February 7, 2014

**Attention: Imported Water Committee**

**Bay-Delta Conservation Plan: Infrastructure Review. (Discussion)**

Figure ES- 1: Location of Facilities

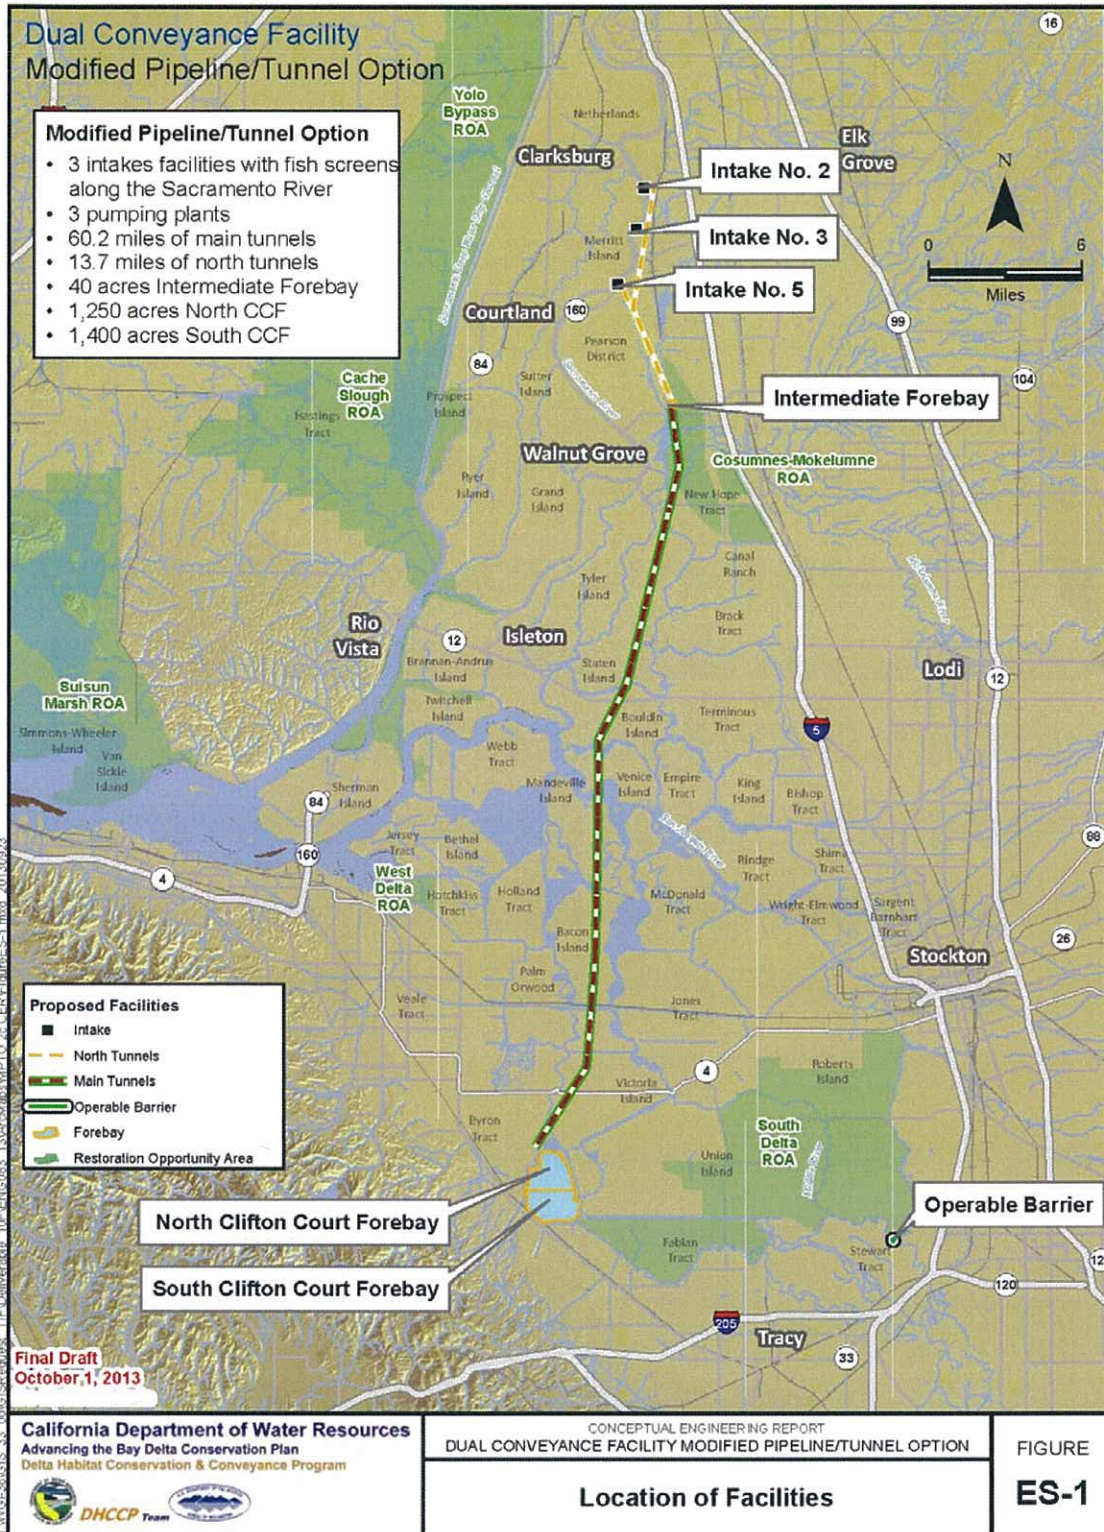
Figure ES-1 showing the proposed tunnel location is attached. The preferred alternative is sized to deliver 9,000 cubic feet per second from the Sacramento River in the North Delta to the South Delta pumping plants. The Conceptual Engineering Report states the preferred alternative will be engineered to protect against a 200-year flood event with sea level rise predicted from climate change, and use gravity to flow through the main tunnels. CER Figure ES-2 identifies the Conveyance Schematic for the preferred alternative.

Figure 13-1: Known Gas Wells and Fields in the Delta Region

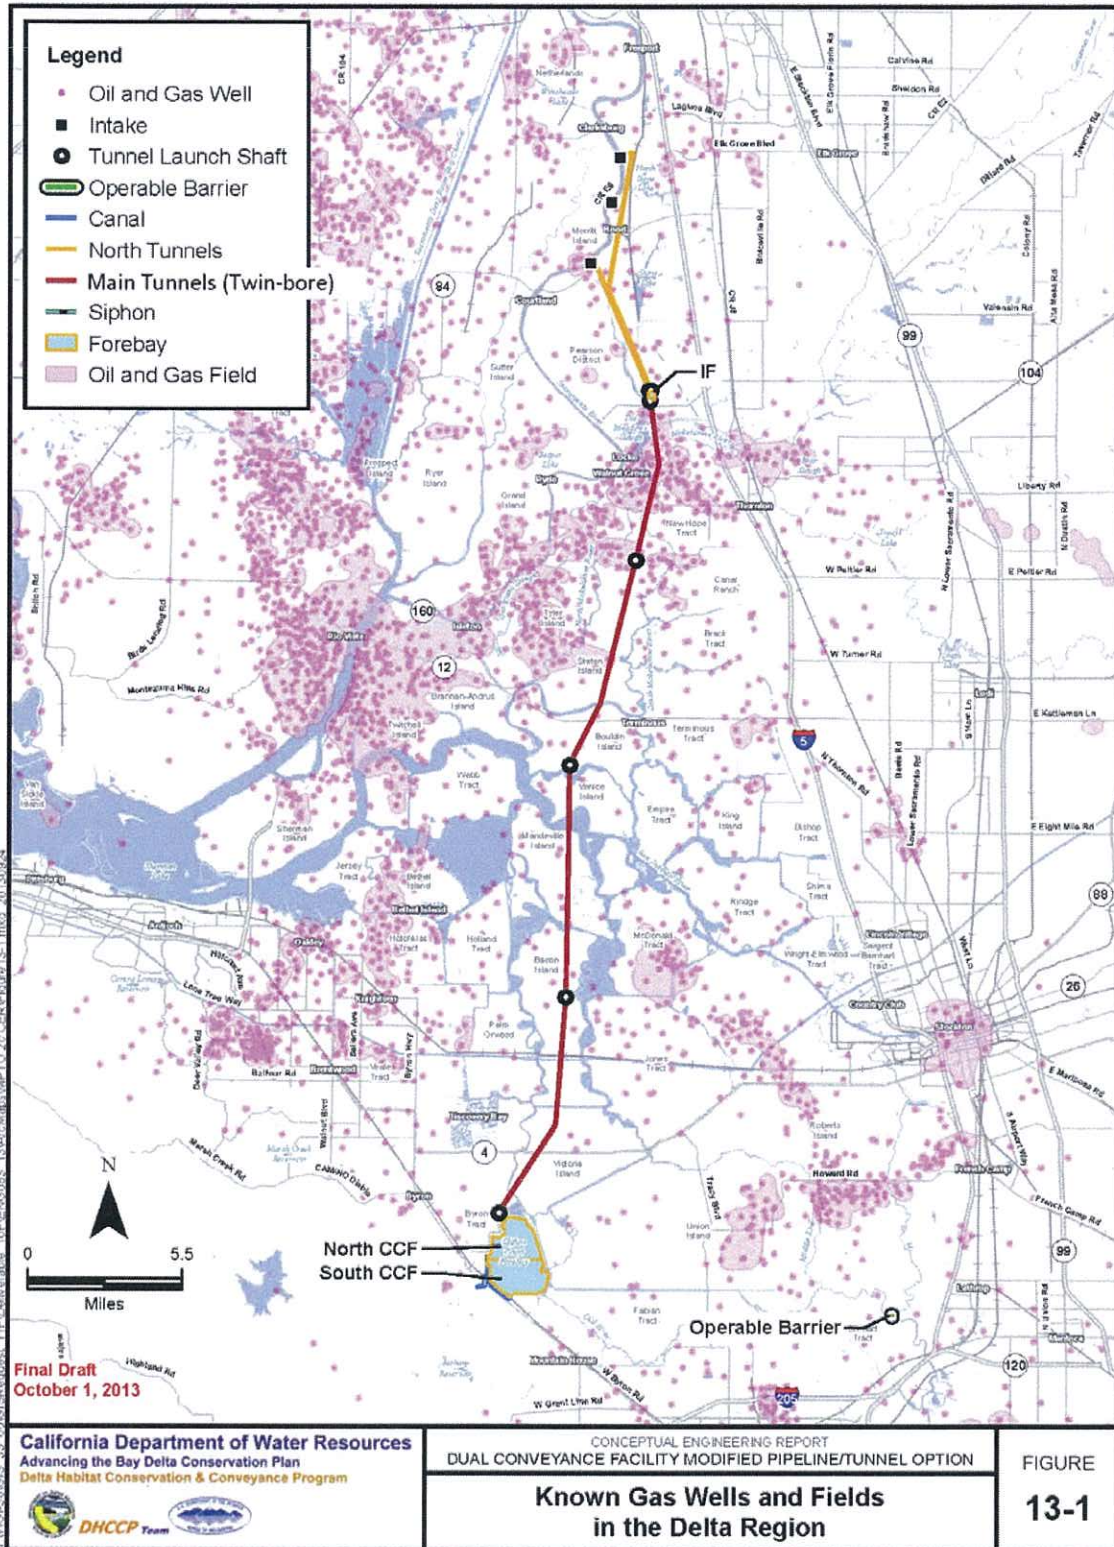
The tunnel alignment extends through natural gas well fields, which are well below the tunnel alignment. The report indicates plugged and abandoned natural gas and oil wells in the conveyance footprint and within borrow and spoil areas. Figure 13-1 from the Conceptual Engineering Report shows Known Gas Wells and Fields in the Delta Region. The report states that abandoned wells within the alignment will require testing and, should they be found to be improperly abandoned, they would need to be improved to meet current California Department of Conservation well abandonment standards.
